**SUBISSUE 4: HLW GLASS DEGRADATION AND RADIONUCLIDE RELEASE**

**Appendix 7 Meeting: Container Life and Source Term**

**July 7-8, 1999, Lawrence Livermore National Laboratory, Livermore, CA**

Ebert et al. (1998)

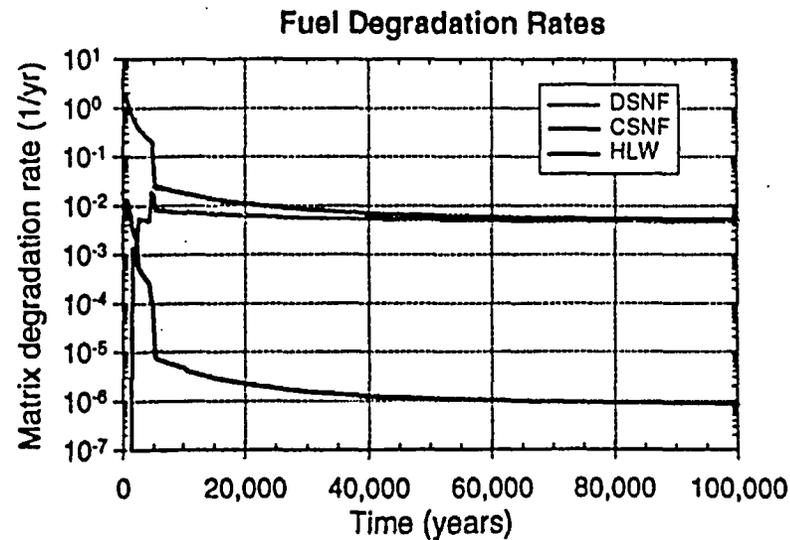
- Stage 3 dissolution rate: leach excursion because of the precipitation of secondary phase
